Ref: Camden - Full Planning Application 2018/5553/P
Site Address - 126 Fordwych Road, London NW2 3PB

Further to my previous comments on this planning application, I believe that the application should be refused for the following additional reasons:-

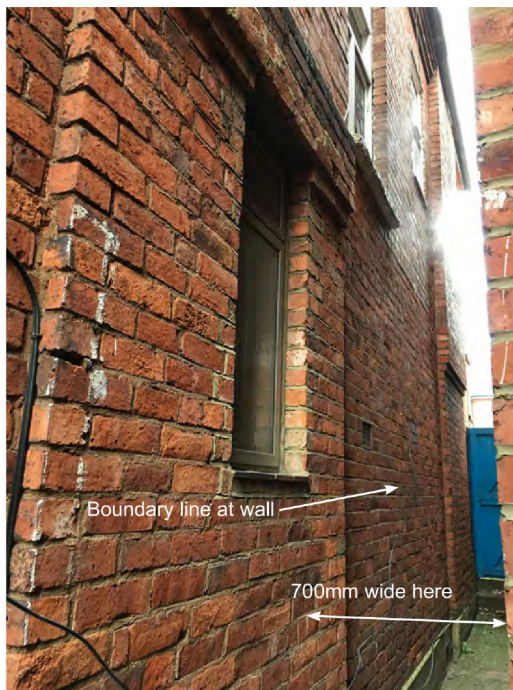
8. There is an additional unauthorised old window opening on the ground floor facing No.124 not shown on the existing plan, that has been closed off internally with plasterboard for over 20 years. As this also presents a spread of fire risk it should be bricked up.

Views of an existing unauthorised window opening in the Ground Floor that is covered with plasterboard internally which should be bricked up to remove the spread of fire risk with 124 Fordwych Rd
